Model: AP-P1		Date: 10-Nov-06	No.: MG133001
Modified Article: SDRAM-DIMM		Prepared by: K. Moriizumi	
From: 1st Tech. Support Sec. Service Support Dept.			
Reason for Modification:	☐ Parts catalog correction ☐ To facilitate assembly ☐ Part standardization	☒ Vendor change ☐ To improve reliability ☐ Product Safety	☐ Other ☐ To meet standards ()

Part Change Information List

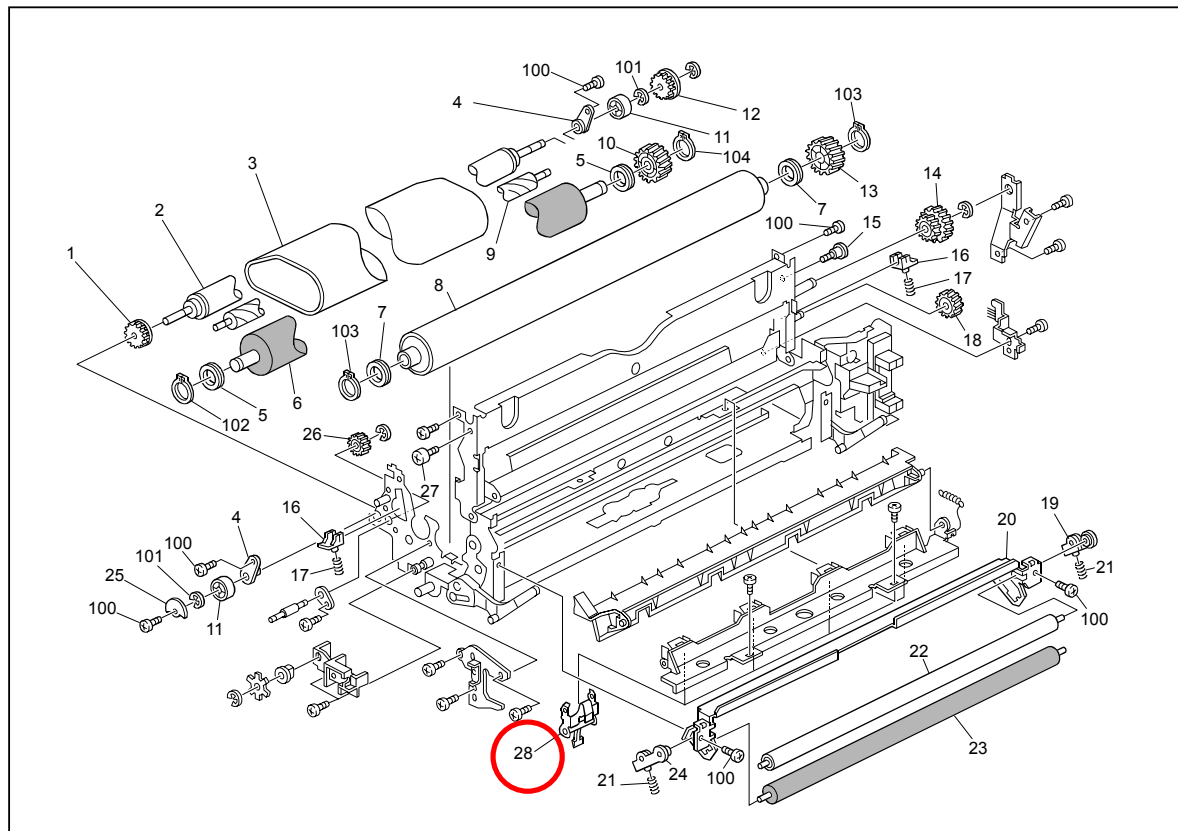
Old part number	New part number	Description	Q'ty	Int	Page	Index	Note
G1335701	G1335705	PCB:Type-JBX4:Sub Ass'y	1 - 1	X/O	65	11

Change/Reason: To facilitate assembly in the factory line.

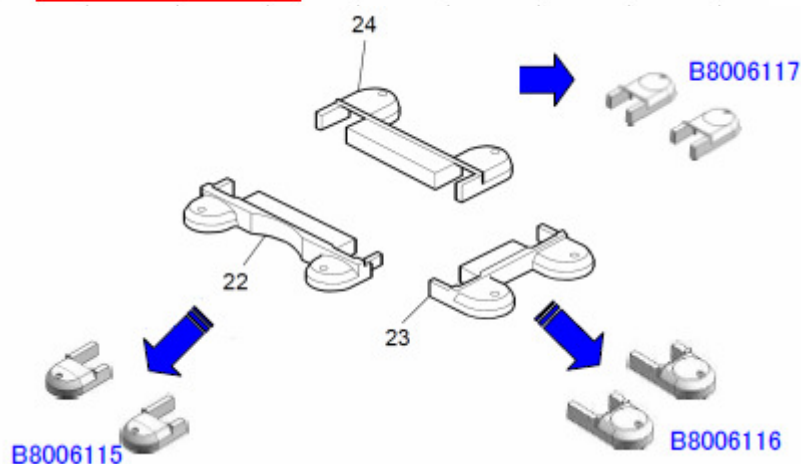
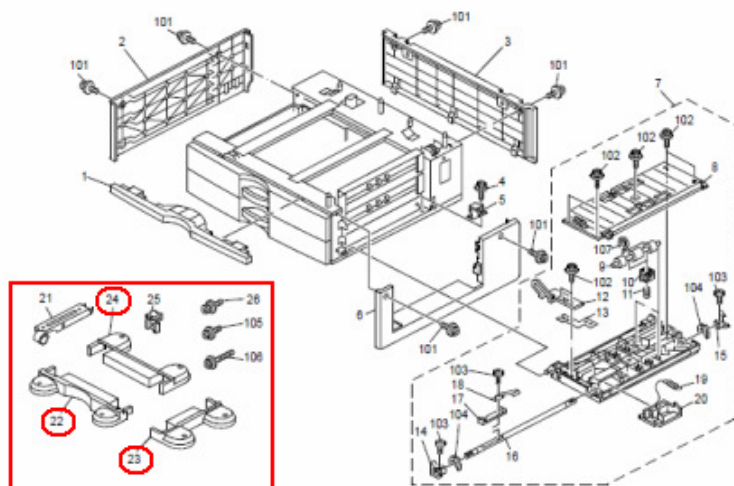
Old part number	New part number	Description	Q'ty	Int	Page	Index	Note
B8016115	B8006115	Arm Cover - Front	1->2	X/O As a set	3	22	
B8016116	B8006116	Arm Cover - Right	1->2		3	23	
B8016117	B8006117	Arm Cover - Rear	1->2		3	24

Change/Reason: The shapes of the arm covers were changed to improve stability.
